**California MLPA Master Plan Science Advisory Team**  
**Summary of SAT Evaluation of Round 2 MPA Proposals for the MLPA South**  
**Coast Study Region: Water and Sediment Quality**  
*(Revised July 13, 2009 per recommendations at the June 18, 2009 SAT meeting)*

### **Overview of MPA Proposal Evaluations Regarding Water and Sediment Quality**

**Figure 4. Proposal 0 scores for coastal MPAs with water quality concerns and the average score.**

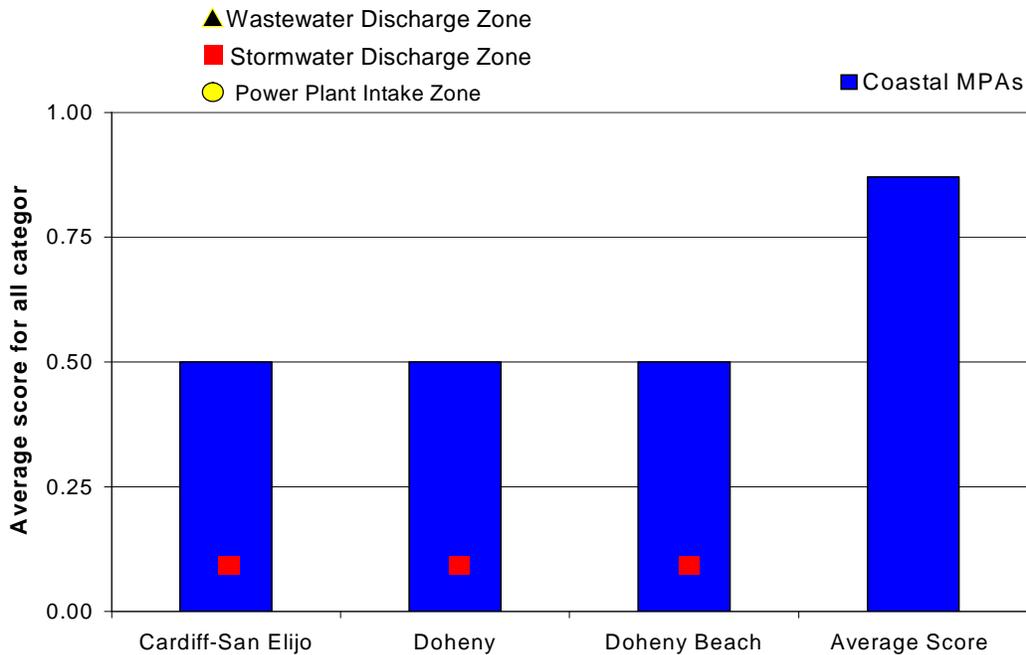
The average score for existing coastal MPAs is 0.87. Not inclusive of NCI, 19 out of 22 coastal MPAs (86%) scored 0.75 or higher. Also not inclusive of NCI, eight of 22 (36%) existing MPAs are co-located within ASBSs (Table 2). Only three out of 22 coastal MPAs scored lower than 0.75 (located within stormwater discharge plumes at San Juan and Escondido Creeks) (Figure 4).

**Figure 5. Lapis 1 scores for coastal MPAs with water quality concerns and the average score**

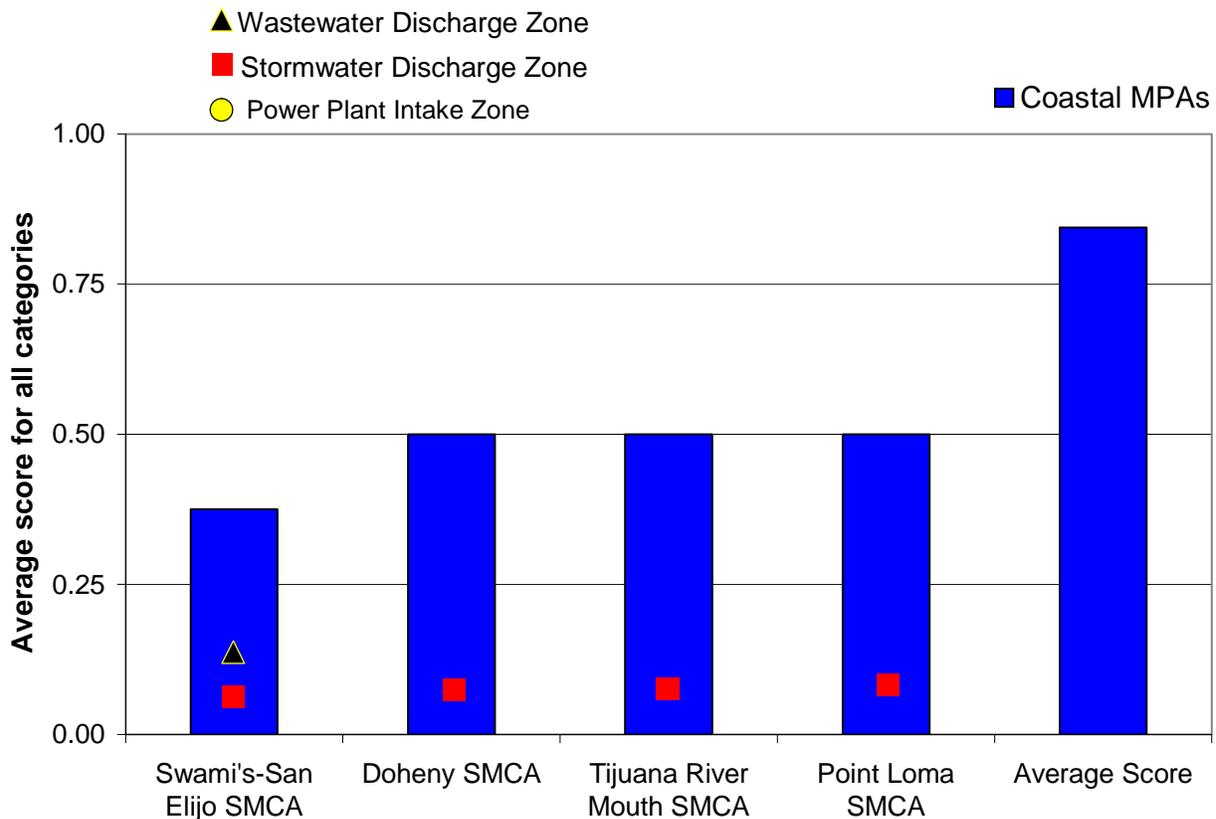
The average score for Lapis 1 coastal MPAs is 0.84 (Figure 5). Not inclusive of NCI, 22 out of 26 (85%) coastal MPAs scored 0.75 or higher. Not inclusive of NCI, ten of 26 (38%) coastal MPAs are co-located within ASBSs (Table 3). There were four coastal MPAs that scored lower than 0.75. Three coastal MPAs (Doheny SMCA, Point Loma SMCA and Tijuana River Mouth SMCA) received reduced scores because they were located within major stormwater discharge zones (San Juan Creek and Pueblo San Diego Watershed respectively). One

coastal MPA (Swamis-San Elijo SMCA) is co-located with both a stormwater discharge zone (Escondido Creek) and a wastewater discharge zone (San Elijo outfall).

**Figure 6. Lapis 2 scores for coastal MPAs with water quality concerns and the average score**

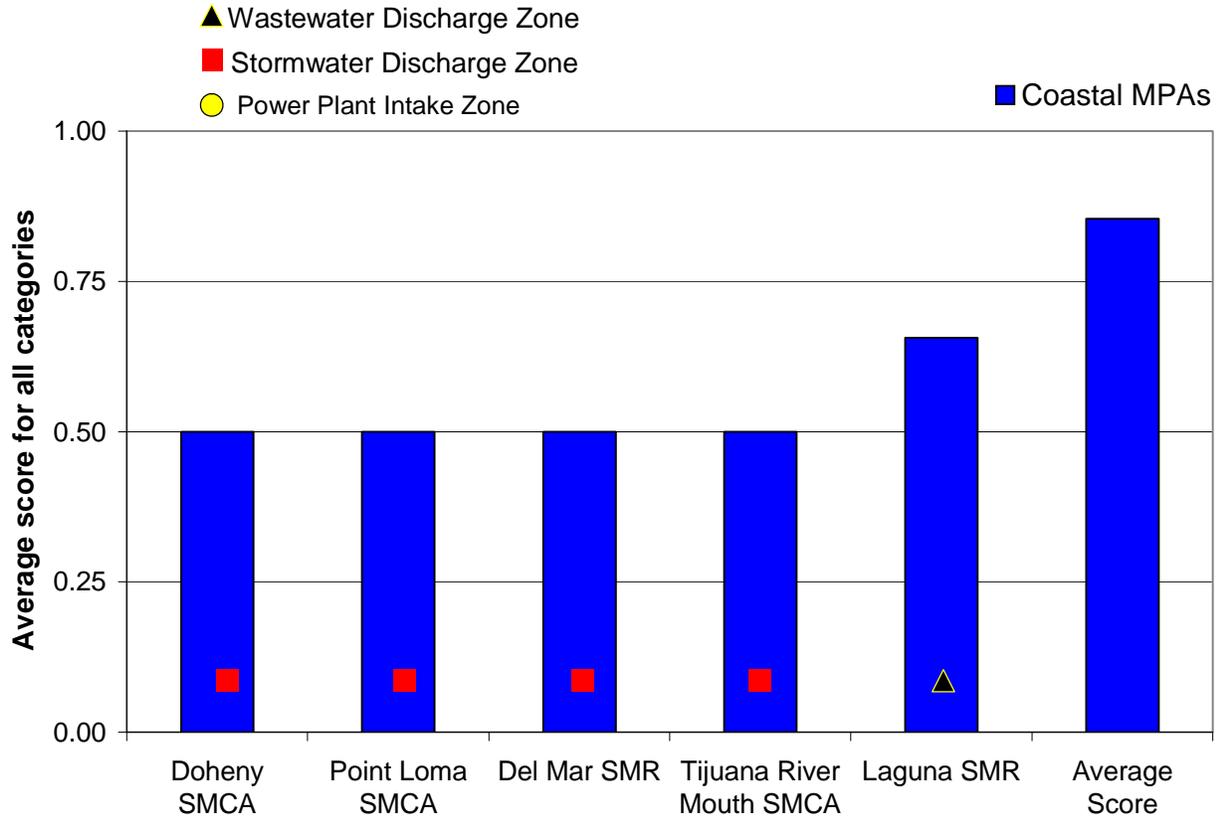
The average score for Lapis 2 coastal MPAs is 0.85 (Figure 6). Not inclusive of NCI, 22 out of 27 (82%) coastal MPAs scored 0.75 or higher. Not inclusive of NCI, ten of 27 (37%) coastal MPAs are co-located within ASBSs (Table 4). There were five coastal MPAs that scored lower than 0.75. Four coastal MPAs (Doheny SMCA, Del Mar SMR, Point Loma SMCA, and Tijuana River Mouth SMCA) received reduced scores because they were located within major stormwater discharge zones (San Juan Creek, Peñasquitos Creek, Pueblo San Diego Watershed and Tijuana River). One coastal MPA (Laguna SMR) is co-located with a wastewater discharge zone (Aliso outfall).

**Figure 7. Opal scores for coastal MPAs with water quality concerns and the average score**

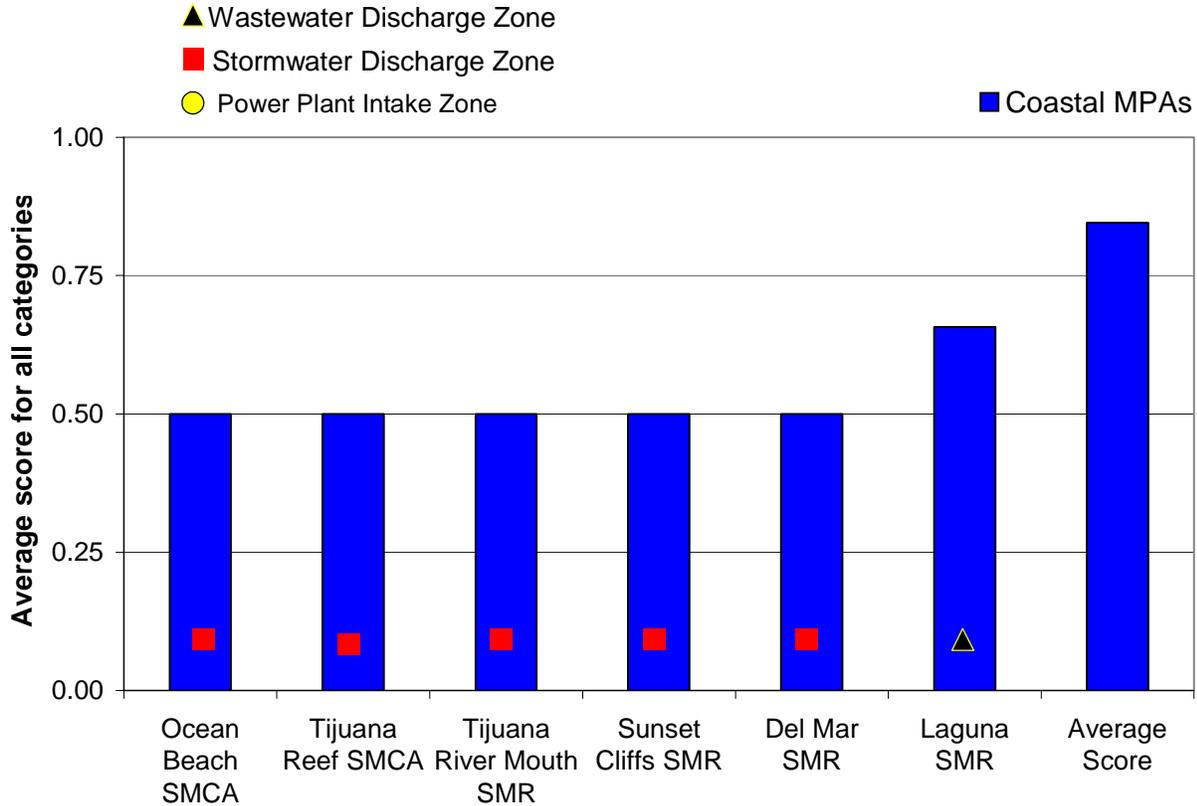
The average score for Opal coastal MPAs is 0.85 (Figure 7). Not inclusive of NCI, 24 out of 30 (80%) coastal MPAs scored 0.75 or higher. Not inclusive of NCI, ten of 30 (33%) coastal MPAs are co-located within ASBSs (Table 5). There were six coastal MPAs that scored lower than 0.75. Five coastal MPAs (Del Mar SMR, Ocean Beach SMCA, Sunset Cliffs SMR, Tijuana River Mouth SMR and Tijuana Reef SMCA) received reduced scores because they were located within major stormwater discharge zones (Peñasquitos Creek, Pueblo San Diego Watershed and Tijuana River). One coastal MPA (Laguna SMR) is co-located with a wastewater discharge zone (Aliso outfall).

**Figure 8. Topaz scores for coastal MPAs with water quality concerns and the average score**

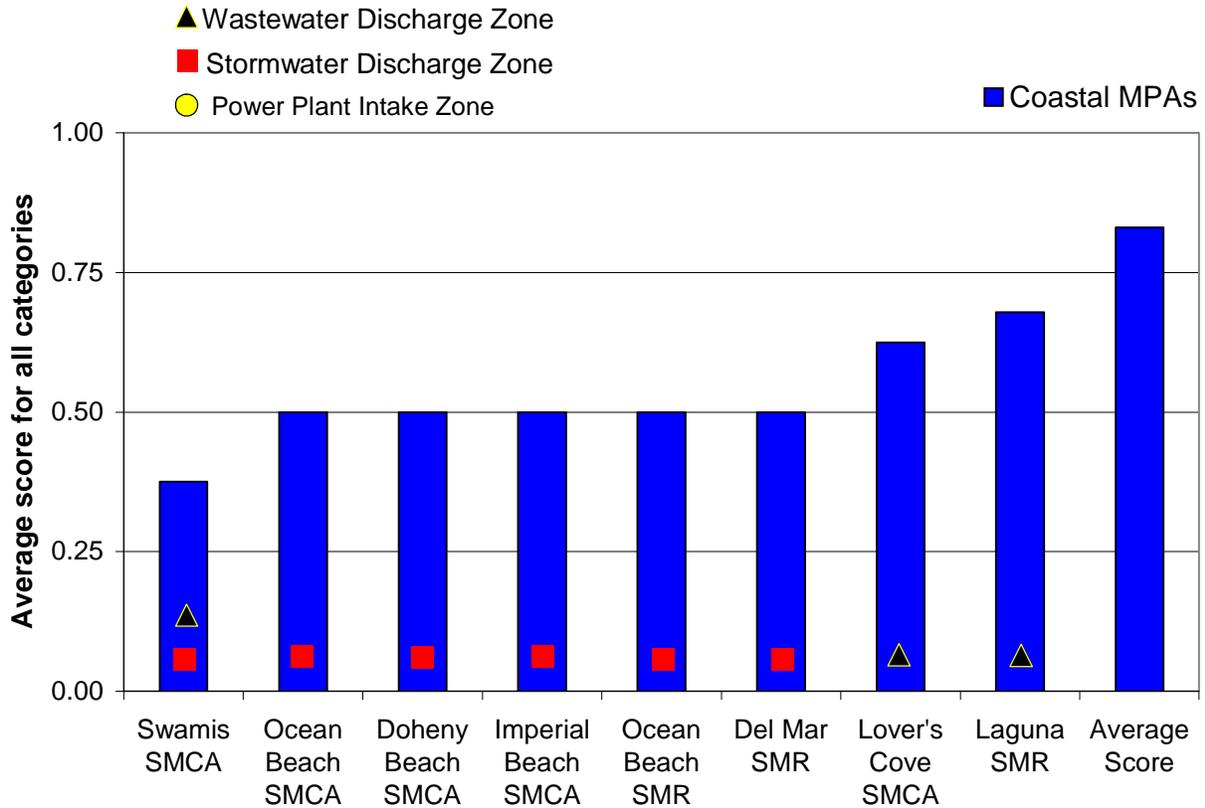
The average score for Topaz coastal MPAs is 0.83 (Figure 8). Not inclusive of NCI, 28 out of 35 (80%) coastal MPAs scored 0.75 or higher. Not inclusive of NCI, 12 of 35 (34%) MPAs are co-located within ASBSs (Table 6). There were eight coastal MPAs that scored lower than 0.75. The Swamis SMCA scored low (0.38) due to location within both a stormwater discharge zone and a wastewater discharge zone. Lovers Cove SMCA and Laguna SMR were co-located with wastewater discharge zones (Avalon and Aliso outfalls respectively). Five other coastal MPAs (Doheny Beach SMR, Del Mar SMR, Ocean Beach SMCA, Ocean Beach SMR and Imperial Beach SMCA) received reduced scores because they were located within major stormwater discharge plumes (Santa Clara River, San Juan Creek, Peñasquitos Creek, Pueblo San Diego Watershed and Tijuana River).

**Figure 9. External A scores for coastal MPAs with water quality concerns and the average score**

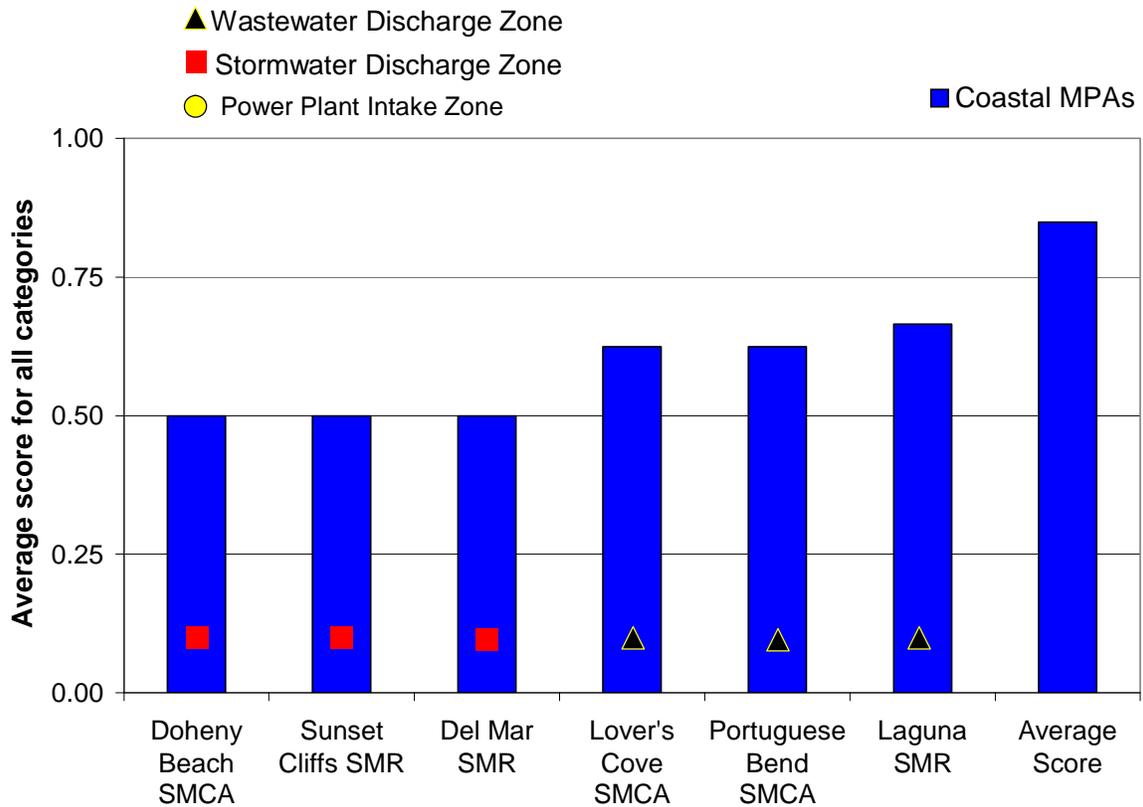
The average score for External A coastal MPAs is 0.85 (Figure 9). Not inclusive of NCI, 20 out of 26 (77%) coastal MPAs scored 0.75 or higher. Not inclusive of NCI, eight of 26 (31%) MPAs are co-located within ASBSs (Table 7). There were six coastal MPAs with scores lower than 0.75. Three coastal MPAs received reduced scores (Lovers Cove SMCA, Portuguese Bend SMCA, and Laguna SMR) because they were located within wastewater discharge zones (Avalon, White Point, and Aliso outfalls respectively.) Three other coastal MPAs (Doheny Beach SMCA, Del Mar SMR and Sunset Cliffs SMR) received reduced scores because they were located within major stormwater discharge zones (San Juan Creek, Peñasquitos River, and Pueblo San Diego Watershed respectively).

**Figure 10. External B scores for coastal MPAs with water quality concerns and the average score**

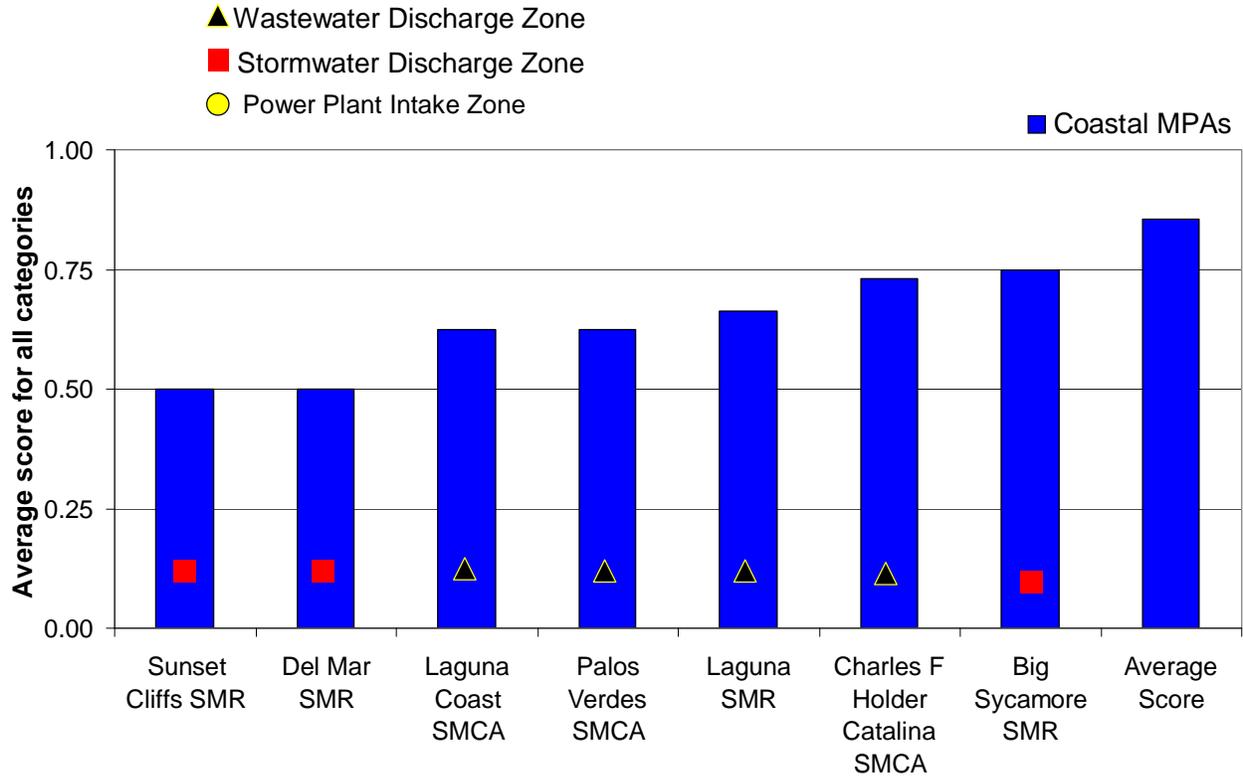
The average score for External B coastal MPAs is 0.86 (Figure 10). Not inclusive of NCI, 20 out of 26 (77%) coastal MPAs scored 0.75 or higher. Not inclusive of NCI, ten of 26 (39%) coastal MPAs are co-located within ASBSs (Table 8). One of the coastal MPAs (Big Sycamore SMR) was co-located with an ASBS but was also located within major stormwater discharge plume from Calleguas Creek, resulting in a score of 0.75. However, there were six coastal MPAs that scored lower than 0.75. Four coastal MPAs (Charles F Holder Catalina SMCA, Palos Verdes SMCA, Laguna Coast SMCA, and Laguna SMR) received reduced scores because they were located within wastewater discharge zones (Avalon, White Point, and Aliso outfalls). Two other coastal MPAs (Del Mar SMR and Sunset Cliffs SMR) received reduced scores because they were located within major stormwater discharge zones (Peñasquitos River, and Pueblo San Diego Watershed respectively).
